FINAL PLAT
ASPEN WILLOW ESTATES

A REPLAT OF A PORTION OF THE SOUTHEAST QUARTER OF SECTION 20,
TOWNSHIP 11 SOUTH, RANGE 66 WEST OF THE 6TH P.M.,
EL PASO COUNTY, COLORADO

PROJECT NO.	25244
DATE:	APRIL 10, 2026
DRAWN BY:	JMJ
CHECKED BY:	MSJ
SHEET:	1 OF 2

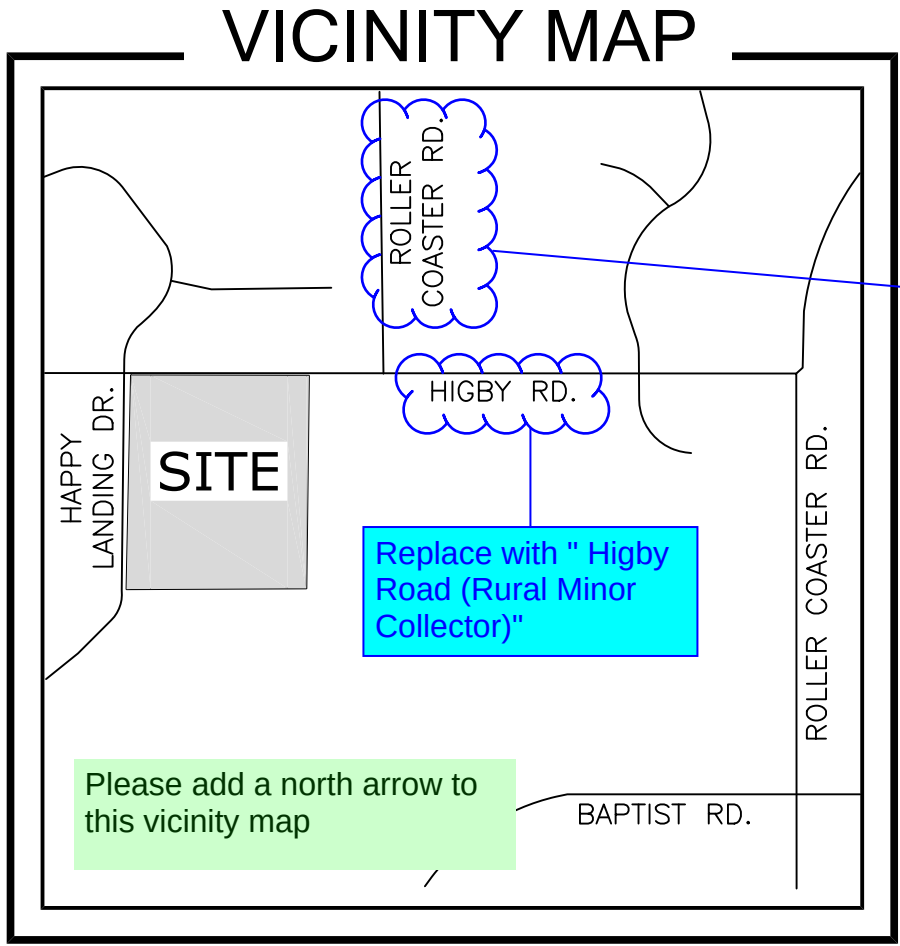
Replace with "Roller Coaster Drive (Rural Major Collector)"

Replace with "Higby Road (Rural Minor Collector)"

Please add a north arrow to this vicinity map

AS CURRENTLY EXISTING

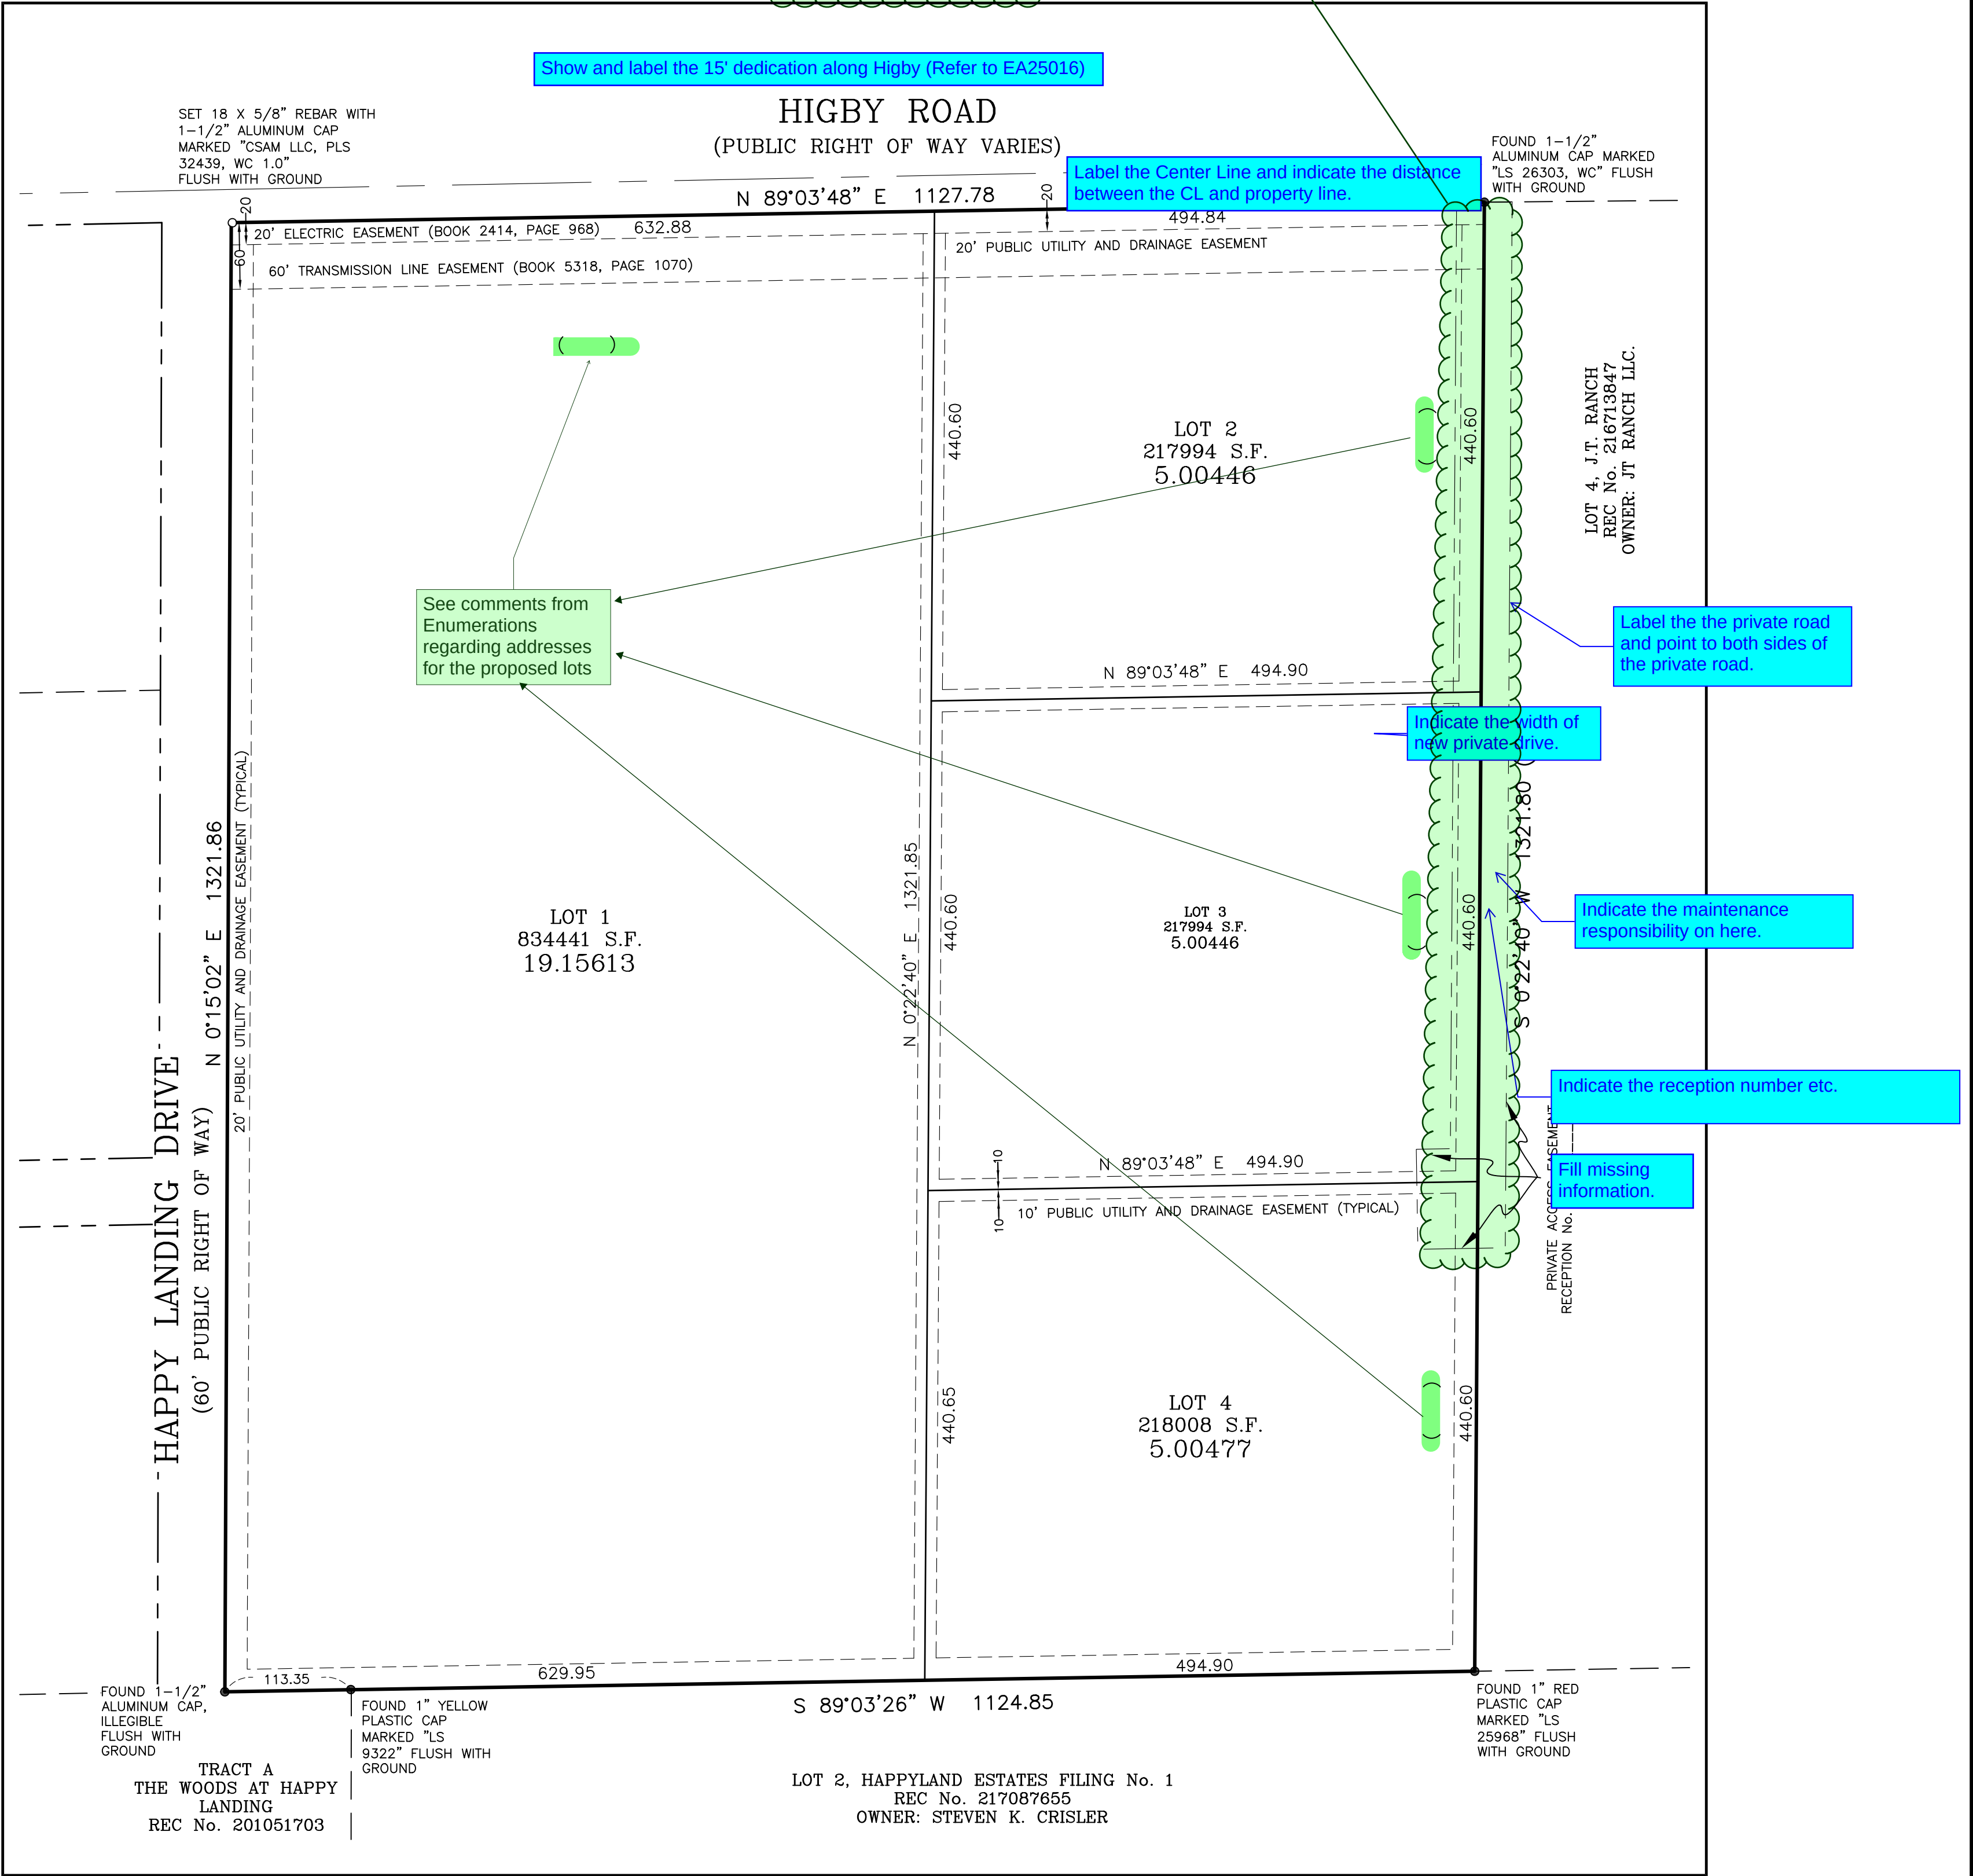
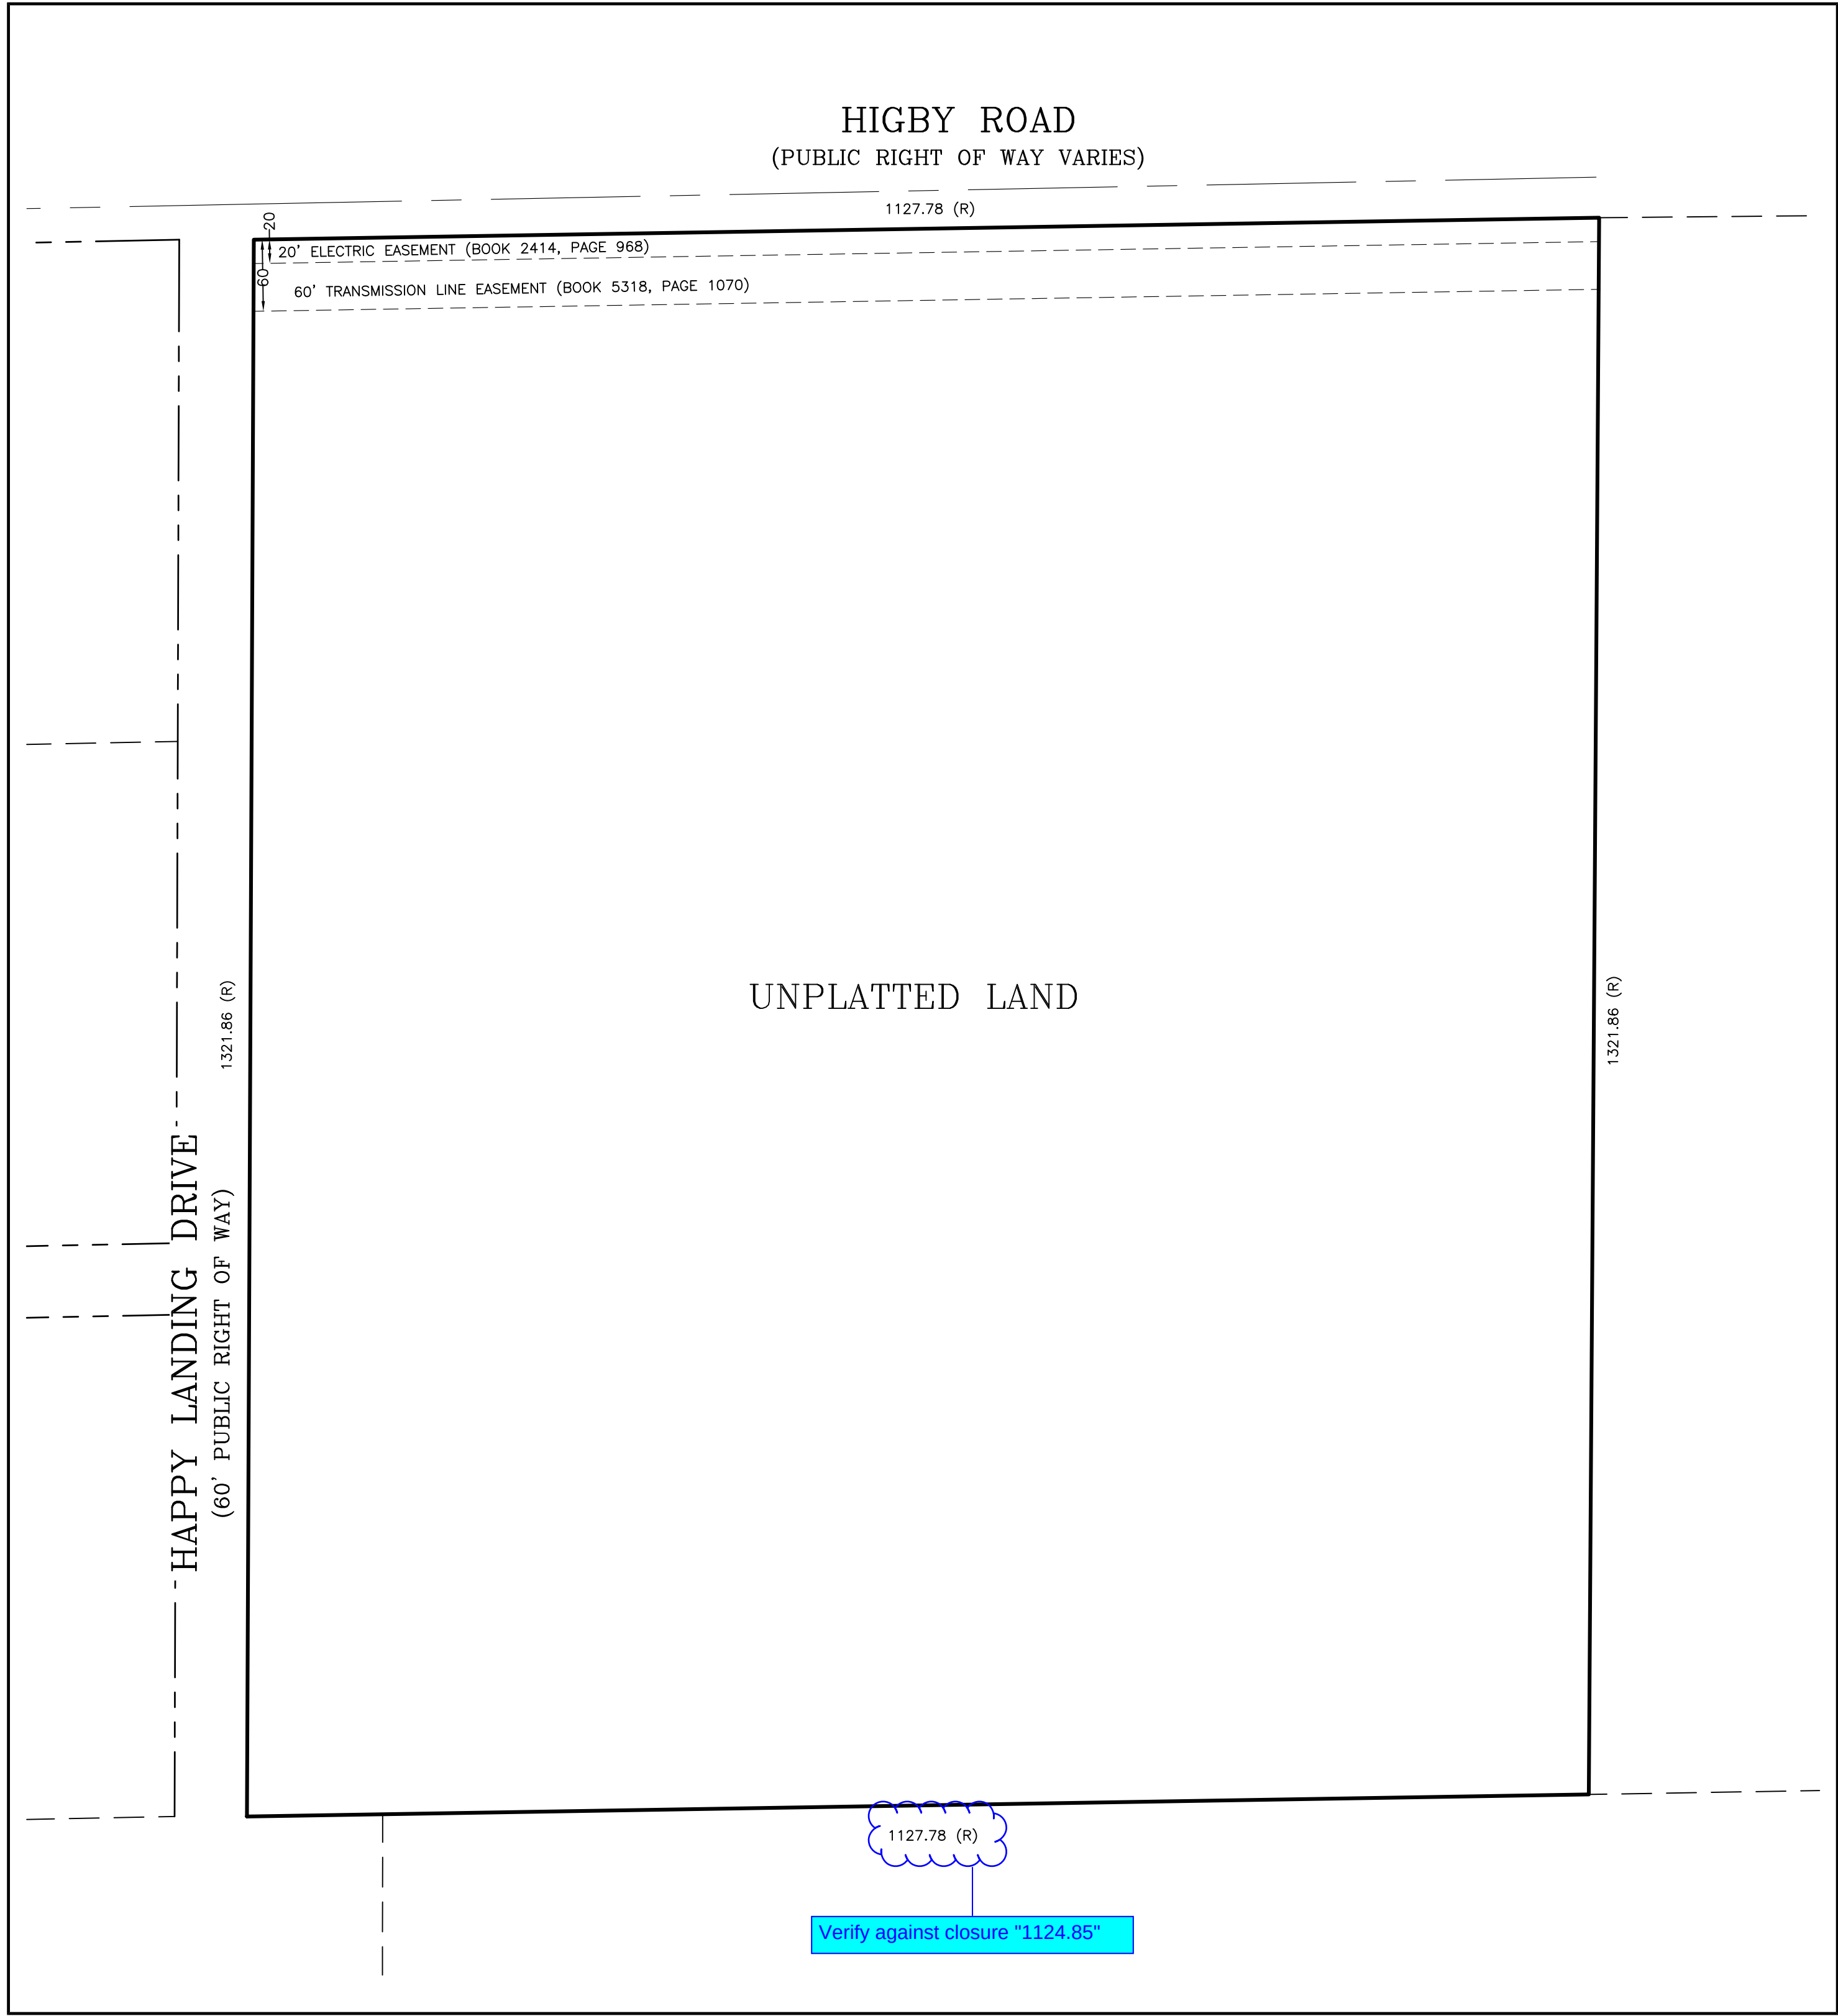
Parcel is not currently
platted, please
change "Replat" to
"Subdivision"

Clarify if this is a private "road" or a private "driveway".
Pursuant to the Land Development Code definition of
"Driveway" below:

Staff recommends that you verify the terms of the Easement
Agreement to determine if a road or driveway is required.

Change to "Proposed"

Please add a north arrow and
scale to this map
